Meeting 45 minutes dated 11 May 2021

**Meeting**: Healthy Floodplains Review

Committee Meeting

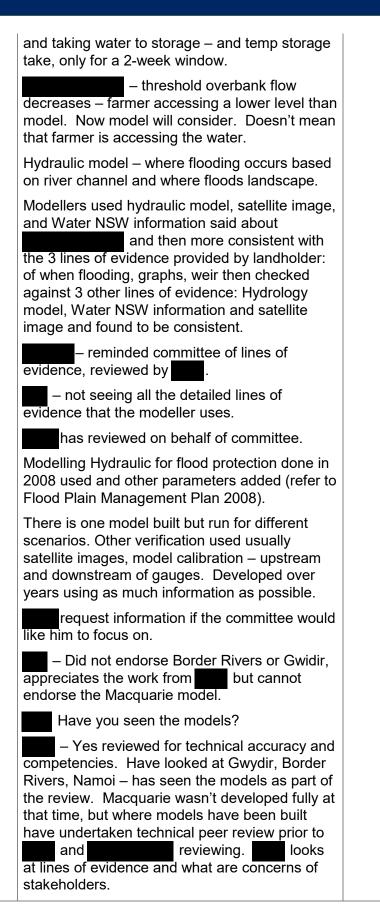
- 5GL change to flood runner.

– was it the size of flood runner or changes to intake – additional temporary storage. 052 – 3 GL large change to intake – is it flood runner or temporary storage change?

– to clarify IQQM bug and temp storage make very little difference, temp storage 5% overbank flow. Field may be flooded for 2 weeks
